# U.S. EPR Data Communications Issues

The purpose of this presentation is to present the staff's findings on the U.S. EPR I&C system architecture and data communications design with respect to meeting the NRC's regulations on functional and communications independence.

# SAS MSRCV Control

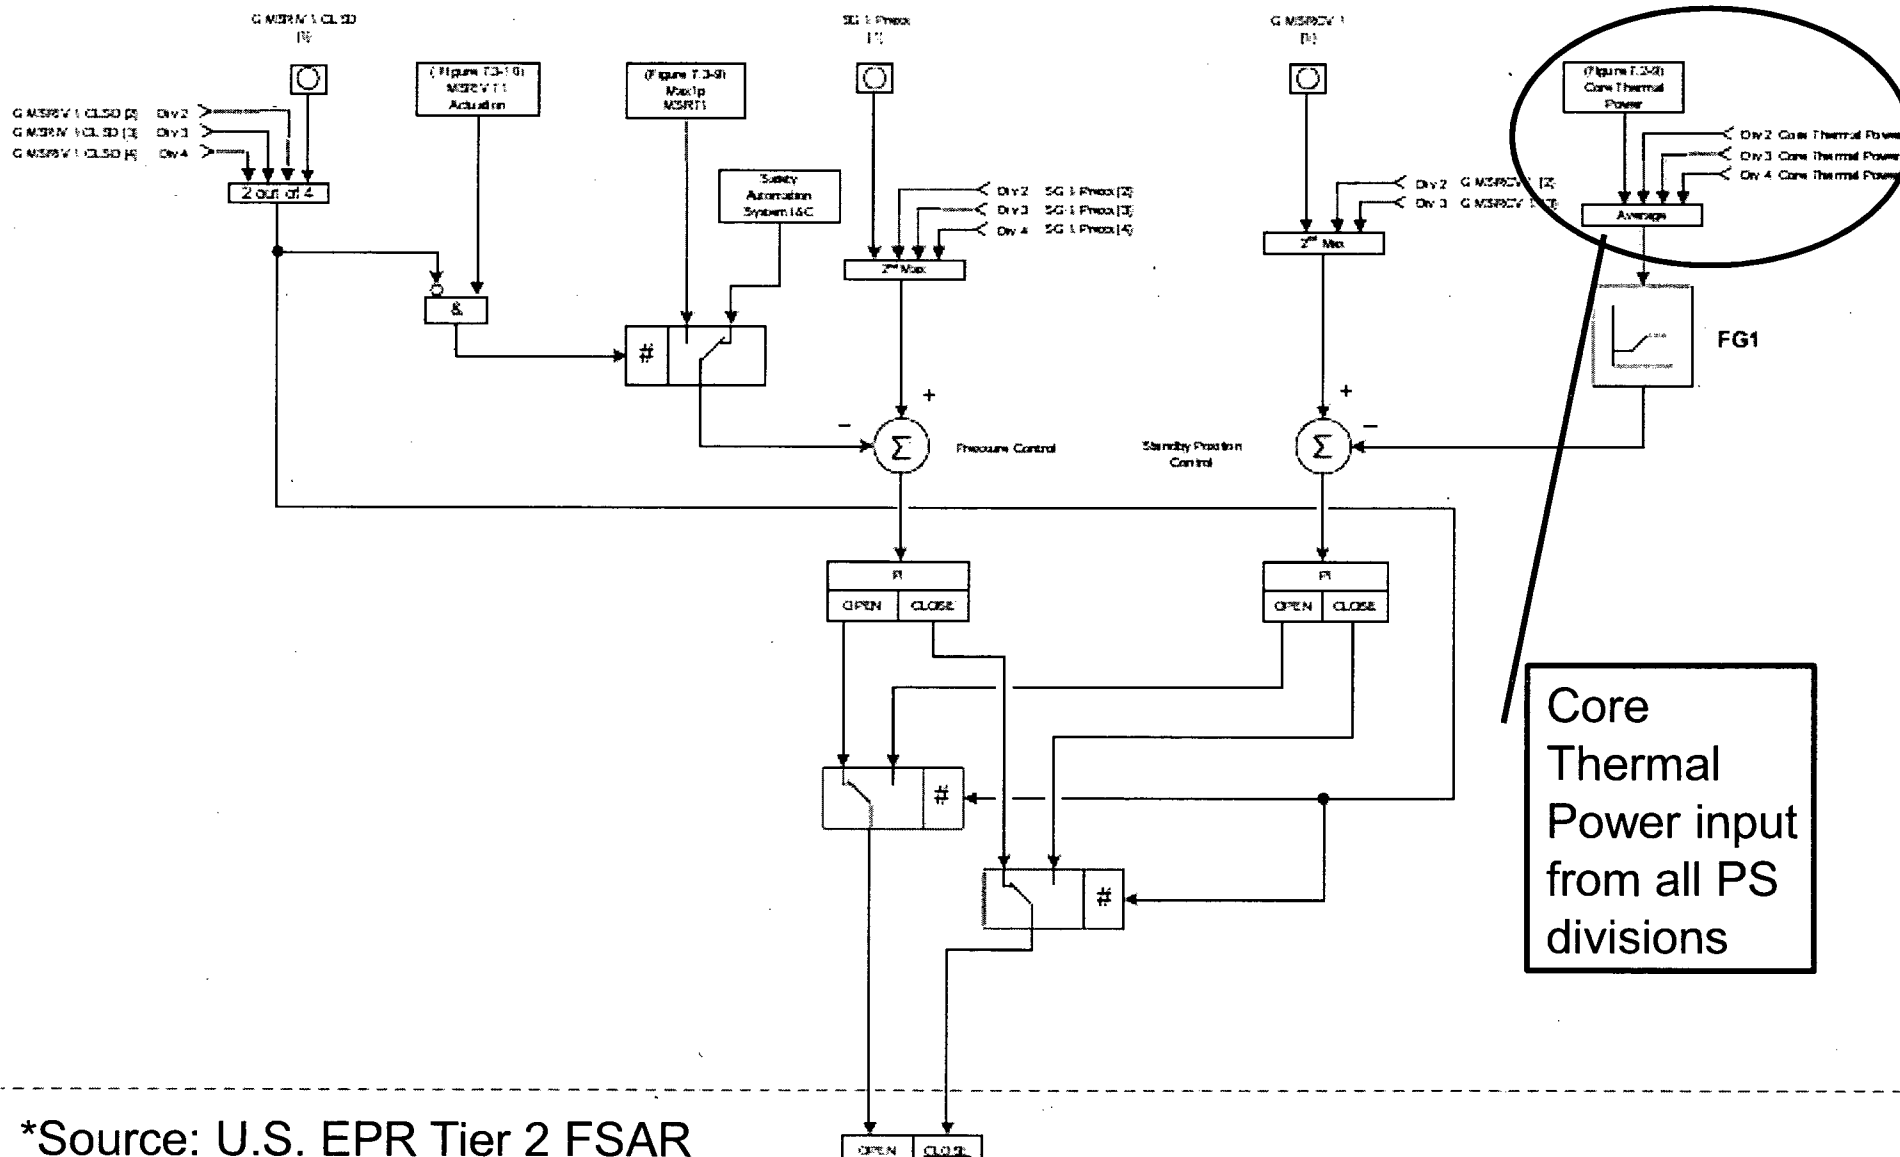
- The U.S. EPR I&C systems design does not meet the fundamental principle of functional independence as required by IEEE Std. 603-1991.
  - Several of the safety functions within the U.S. EPR design requires information from outside its own division to accomplish the safety function. Examples include:
    - Incore power measurements for DNBR and Linear Power Density Reactor Trip functions
    - Main Steam Relief Control Valve Control for ESF functions
  - Protection of SAS and PS from adverse influence from PICS is provided with operator action from SICSp

# Simplified U.S. EPR I&C Architecture

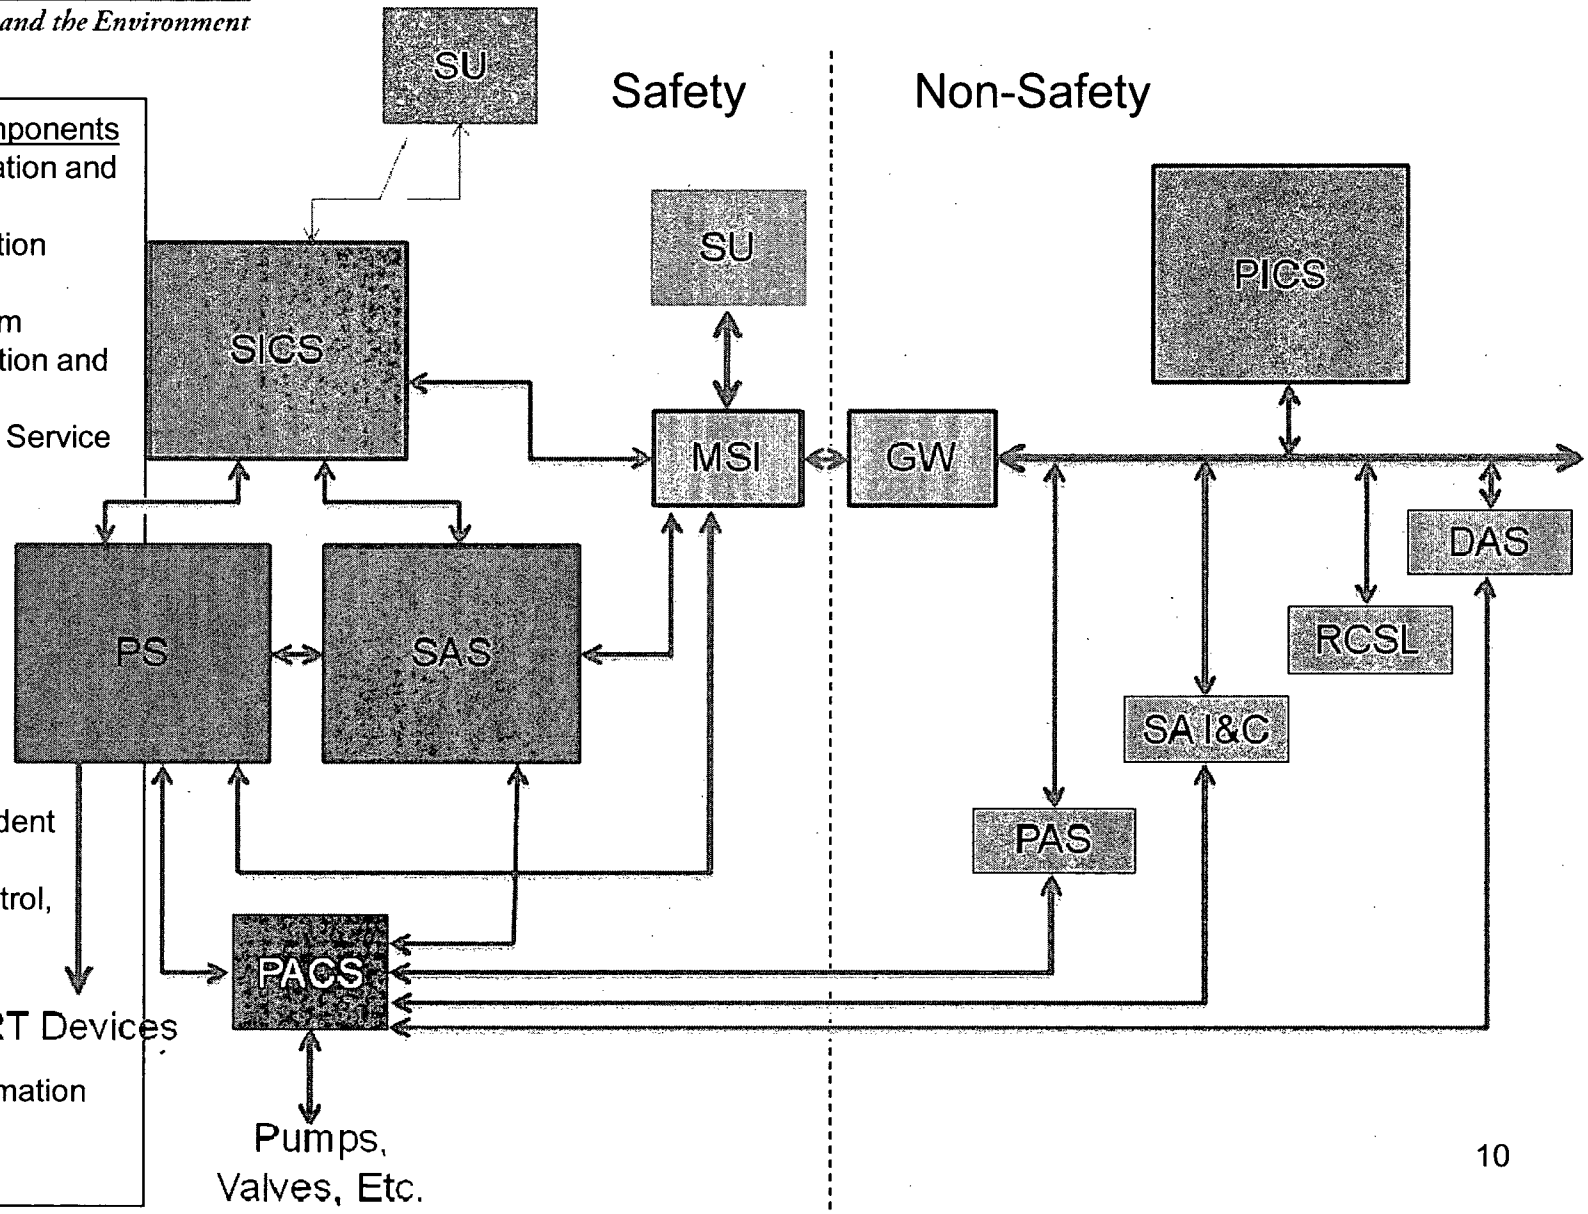
- In the original submittal and in subsequent responses to RAI 286, AREVA NP did not demonstrate how the U.S. EPR design addressed the criteria within Section 1 and 3 of ISG-04, or describe an acceptable alternate approach to meet NRC regulations on independence.
- AREVA NP has also not identified all interfaces between redundant safety division or between safety and non-safety equipment.
- Bi-directional flow exists between many safety to non-safety interfaces, and between safety divisions.

# Data Communication For One Division of PS

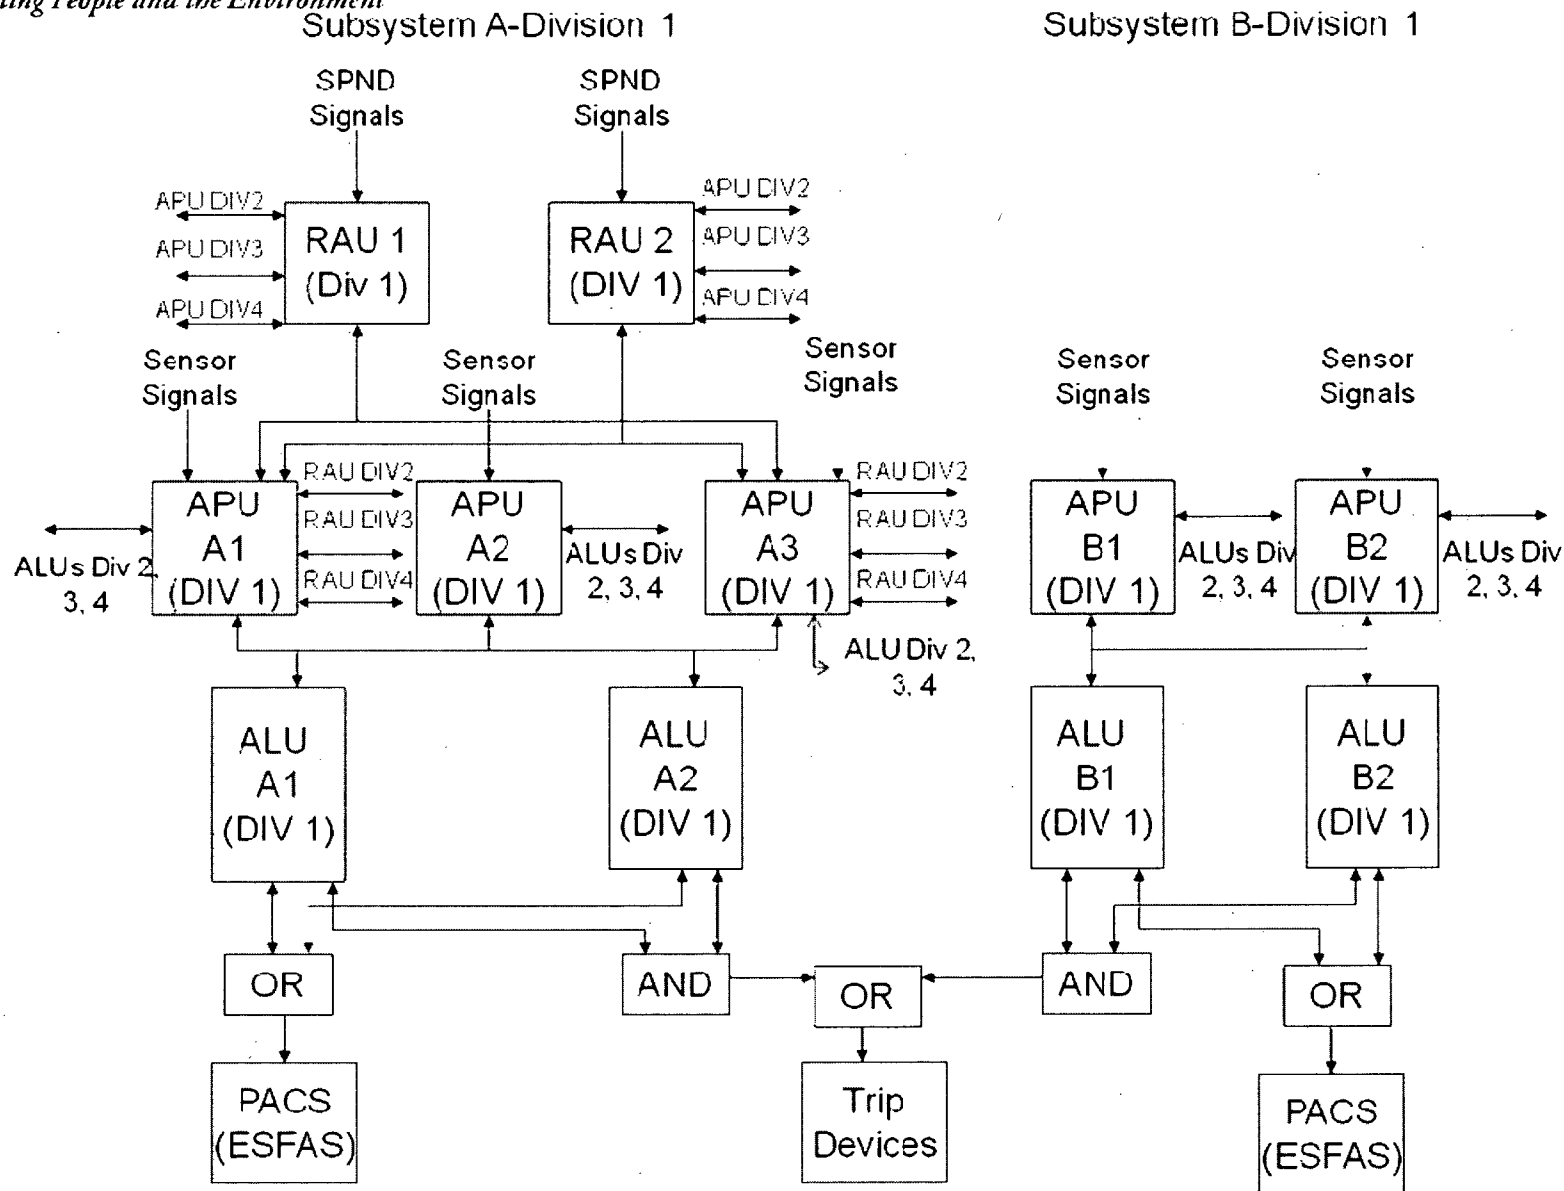
- The applicant has not demonstrated how each criteria of ISG-04 for communications independence is satisfied or have provided sufficient justification on why an alternate approach is acceptable. Examples include:

- Sect 1, Crit. 3: Insufficient justification for why safety divisions need to receive any communication from outside its own safety division. The communication does not enhance or support a safety function.

- Sect 1, Crit. 8: No justification on why data exchange between redundant safety divisions or between safety and non-safety equipment is processed in a manner that does not adversely affect the safety function.

- Sect 1, Crit. 10: Insufficient justification for continuous connection between non-safety related Service Unit and Safety Systems.
- The applicant only makes claims to conformance with certain criteria within ISG-04, and does not provide sufficient evidence to support the claim.

- To achieve functional independence, the applicant must present a design such that it assures each safety division can perform its safety function independent from information received from outside the division\*.
- To ensure that the design presented for this application can be demonstrated to meet communications independence requirements, the applicant should provide a simpler design for data communications between safety divisions, and between safety and non-safety equipment with sufficient justification and evidence for the staff to reach a reasonable assurance finding
